City of Portland
Bureau of Development Services
Land Use Services Division

Date: October 20, 2008
To: Kurt Schultz, Sera Architects
From: Noelle Elliott, Development Review
Phone number 503-823-7812
Re: 08-136009 DA – Wyndham Hotel at NW 14th Ave & NW Irving St
Design Advice Request Summary Memo for October 2, 2008

This memo summarizes **Design Commission** design direction provided at the October 2, 2008 DAR.

*South Elevation
(facing Irving Pedestrian Pathway)*

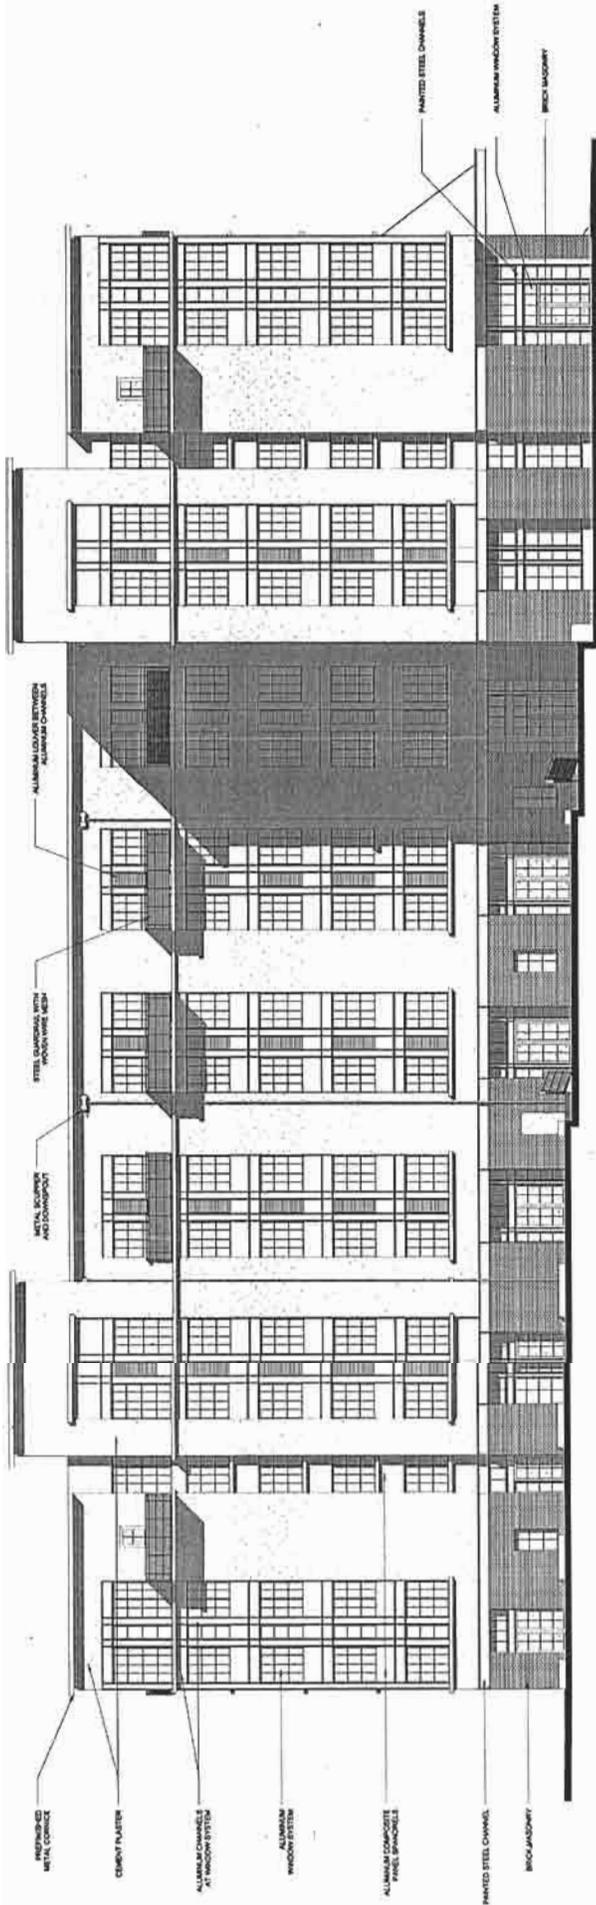
- The building has a 20,000 SF footprint, with 400-ft of street frontage, and effectively (as it relates to the activity on the sidewalk), 250 ft of that frontage is dead to the world. This program has been dropped onto this site and is not relating to its context. Guidelines A8, B5, and C9 are not being met – at least 250 ft of the building in the current condition will never meet those standards and is not approvable. The design doesn't meet the spirit of the standards; it is not activating the corner or the pedestrian way.

- Consider filling in the light-well (courtyard) at ground level with commercial, outward focused program at the ground floor. You have the opportunity to become part of the Pearl District community and to address the public environment. The pedestrian walkway is an incredible public amenity that you are orienting units towards, but you're not giving anything back to the public space. It is segregated from the Pearl District. Your current design is doing a good job at excluding the public and separating the hotel from the Pearl District.

- You have two clear options, make a public courtyard, or make an active retail edge along Irving. If the courtyard stays, it should be a public garden courtyard, without a barrier, and the ground floor must incorporate substantial commercial space.

- The courtyard should be a public amenity, one that invites the public in and interfaces with the neighborhood – that is the spirit of Portland. The private courtyard suggests that guests want to look at, but not interact with the public. If you want the Pearl District to be your clients/community, then invite it in. Consider embracing the neighborhood, opening things up and allowing people to interact with the courtyard. It would be positive for the organization and the community if the design embraced the neighborhood. The Commission has made a very strong effort to open up courtyards in the Pearl District – there is an extensive history of this being met and working well. A private courtyard and a private ground floor effectively take the building off of the block as it relates to the pedestrian realm.

- The building is not creating a gateway at the ground floor, as you intend. Could there be a canopy at the ground floor on the Pedestrian way that marks the Commission's requested active "retail" corner? An awning at 14th and Irving would be helpful to provide a gesture that indicates that this is a pedestrian gateway. The unfixed seating at 14th & Irving, isn't successful. Fixed seating would be a nice gesture to the neighborhood. Art would be another nice addition to the corner.

*West Elevation
 (facing NW 15th Ave)
 EA 08-136009 DAR
 2nd DAR hearing*

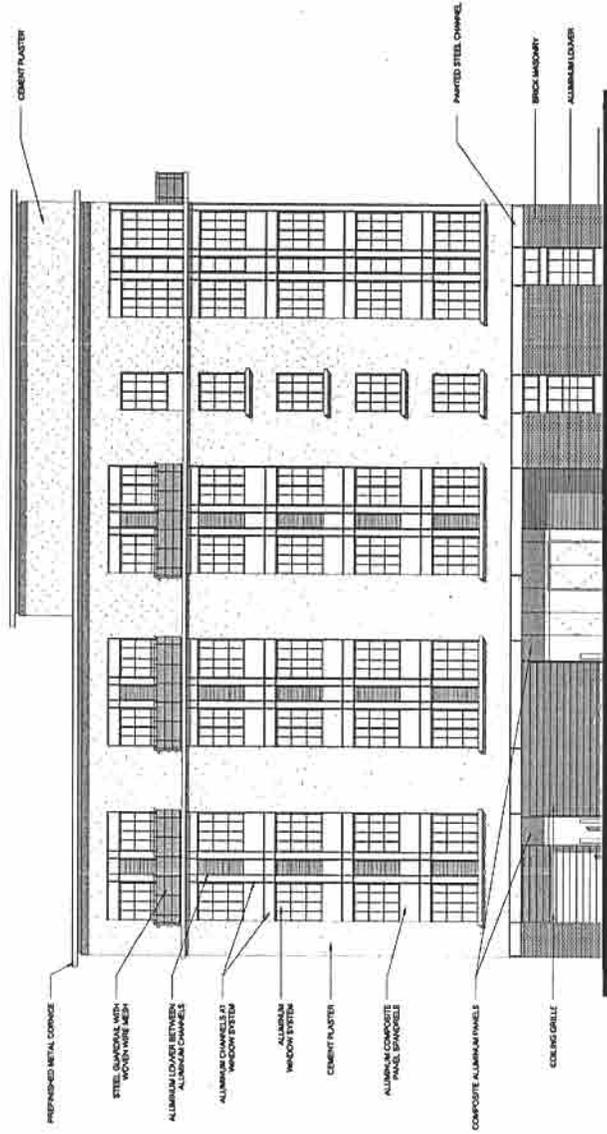
- The intention of active ground floor corners is not accomplished on 15th Ave.
- Consider a canopy at the loading area, which is what traditionally happened along 15th Ave loading docks.
- Making the doors glass would create a better sense of pedestrian safety and openness.
- In rethinking the ground floor, consider commercial space or something more active happening on 15th Ave. Consider tucking a restaurant or commercial space into the 15th Ave façade, it might be a very dynamic location for a little restaurant.
- Bikes on 15th Ave might work well.
- A more flush approach to vehicular entrances on 15th Ave might be an improvement. Setting them back creates too much shadow.
